AVALON PARK
AN ADDITION TO WICHITA
SEDGWICK COUNTY, KANSAS

RE: SUB 2002-144 -- Final Plat of Avalon Park Addition

RE: SUB 2002-144 -- One-Step Final Plat of Avalon Park Addition

CASE NUMBER: SUB 2002-144 -- AVALON PARK ADDITION

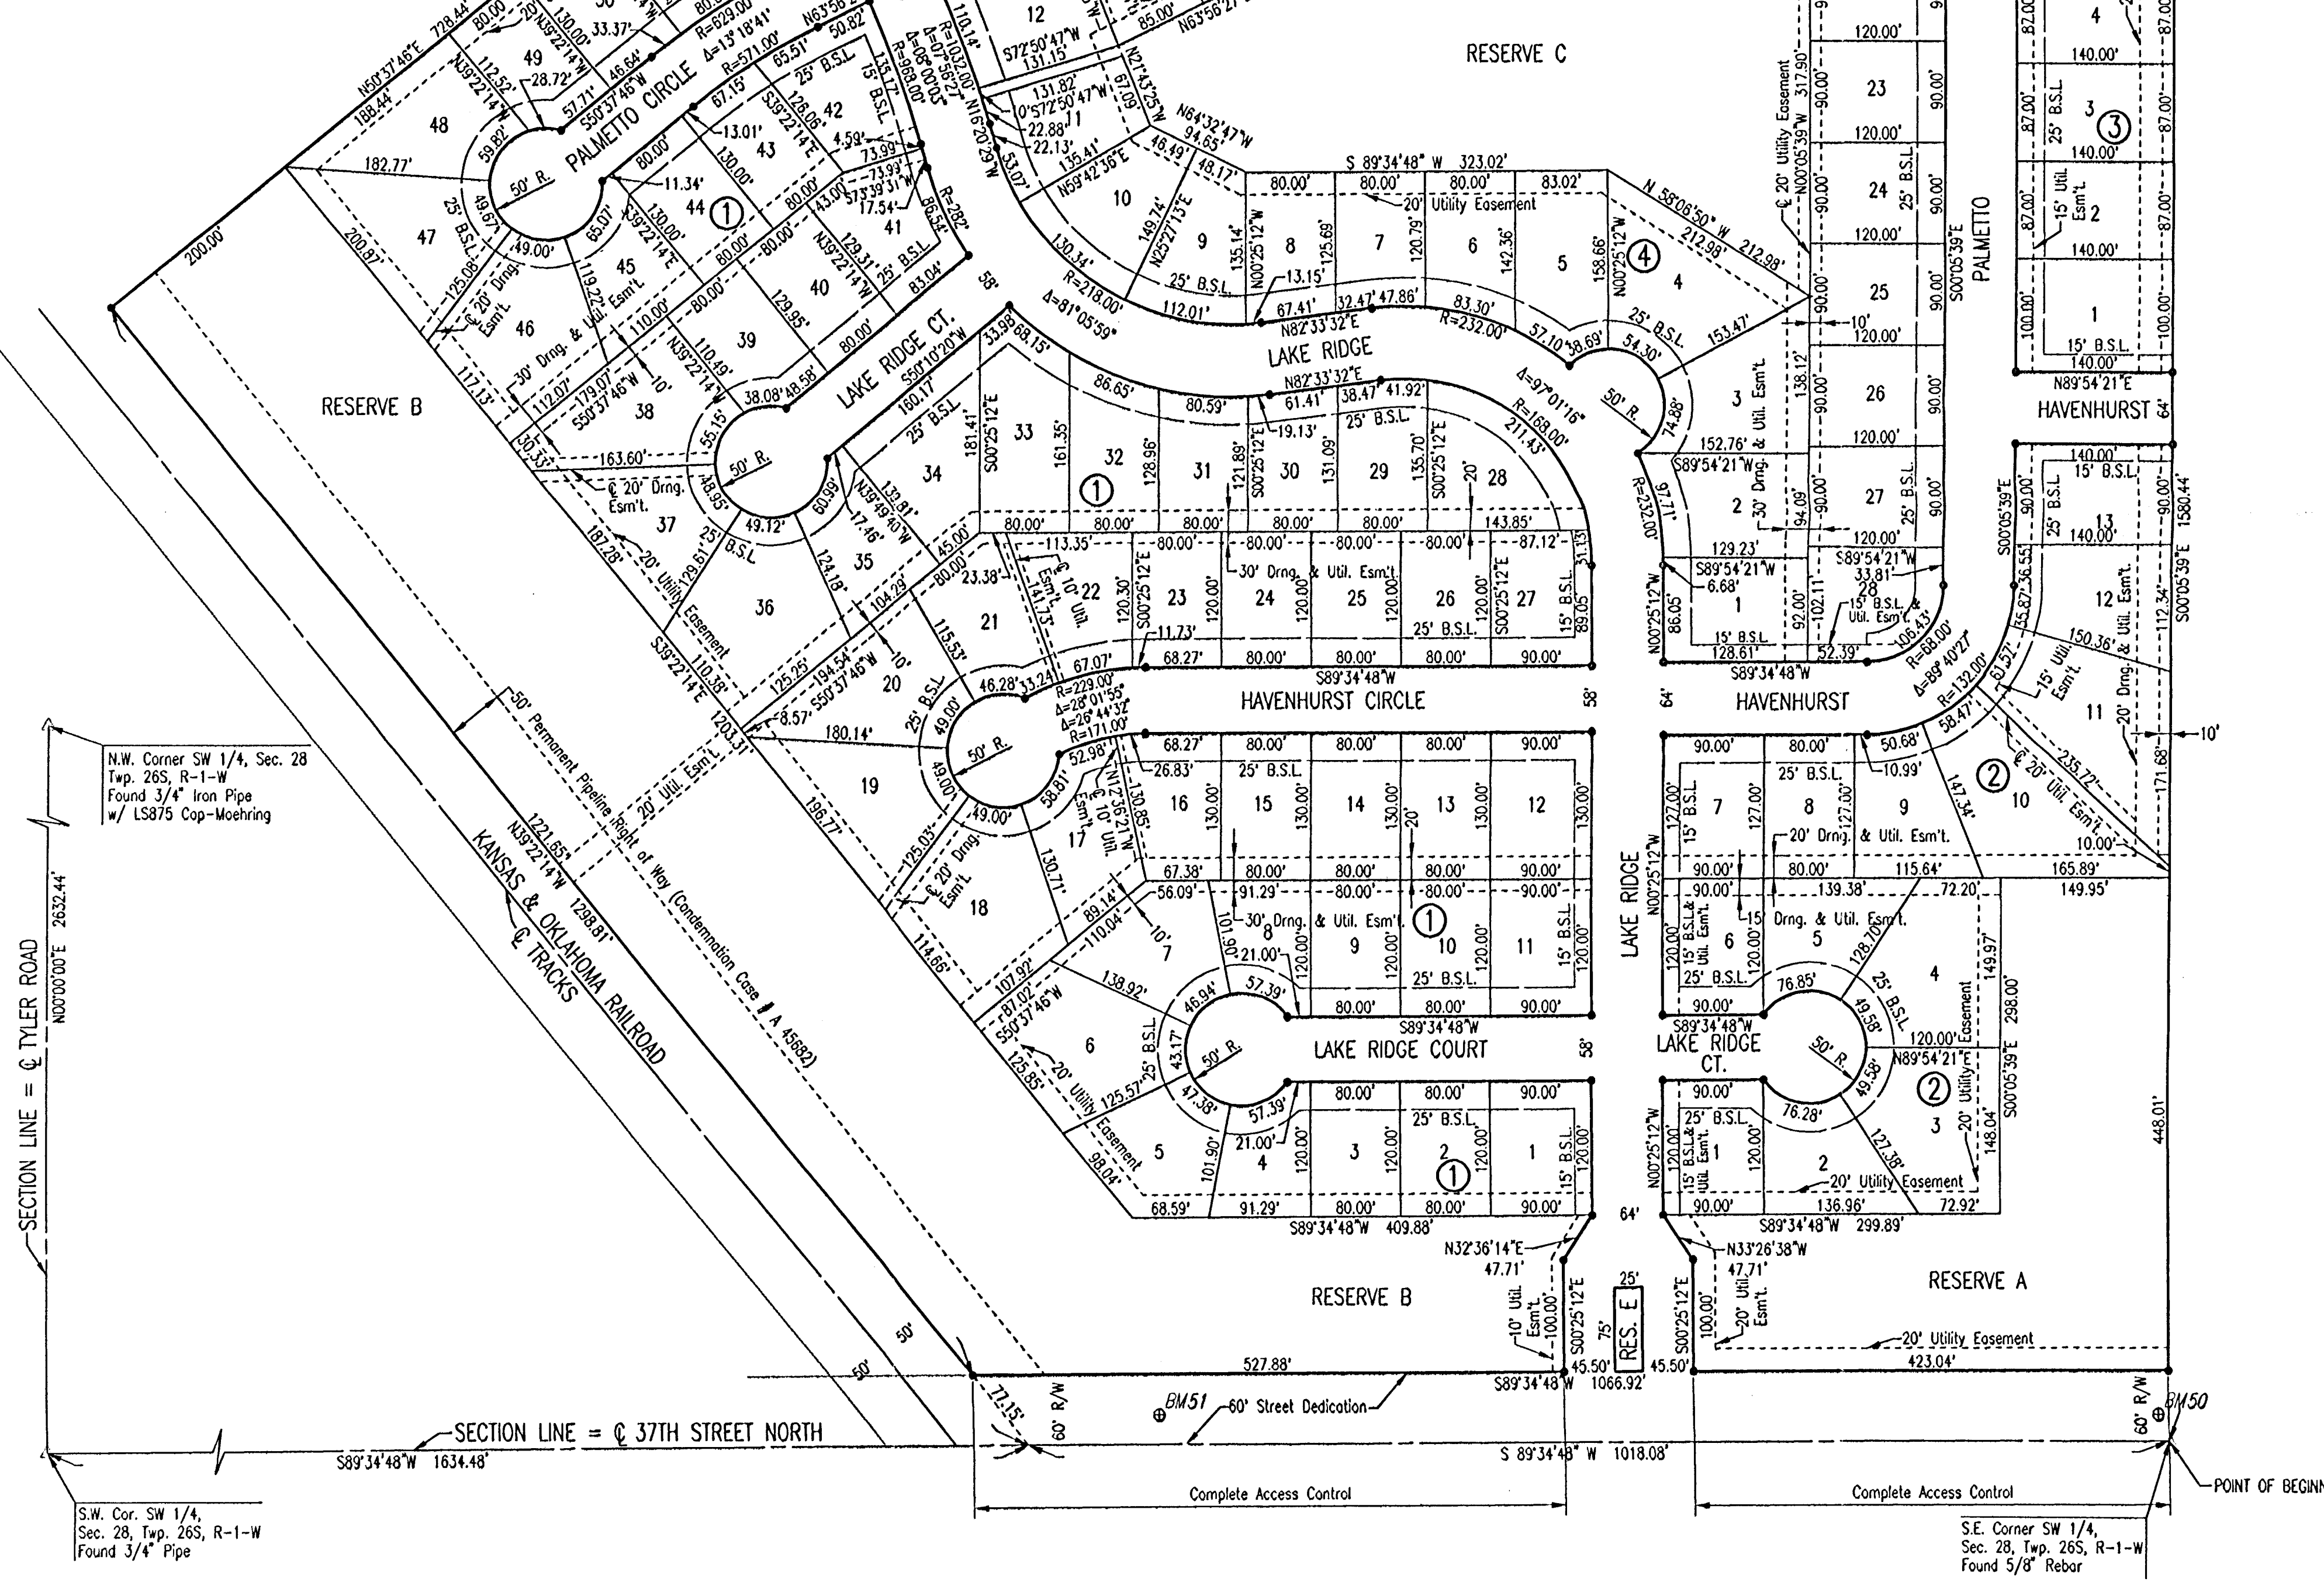
- D. City Engineering has approved the drainage plan. An off-site drainage easement is needed. City Stormwater Management advises of a possible need for a FEMA Map Revision in addition to permit approval by DWR and the Corps of Engineers. County Engineering requests the grading of the north roadside ditch to allow stormwater to flow from the railroad tracks to the big slough. An error on discharge from pond 4 needs to be corrected to show 25 CFS, not 18 CFS.

- H. It is recommended that Reserve C be extended to the street by narrow strips of Reserve between the lots to increase their accessibility and usefulness for all homeowners in the Addition.

- N. County Surveying requests that bearings be denoted on lot lines
- O. The City Fire Department/GIS needs to comment on the plat's street names. New street names are needed.

- Y. The representatives from the utility companies should be prepared to comment on the need for any additional utility easements to be platted on this property. Westar Energy requests additional easements.
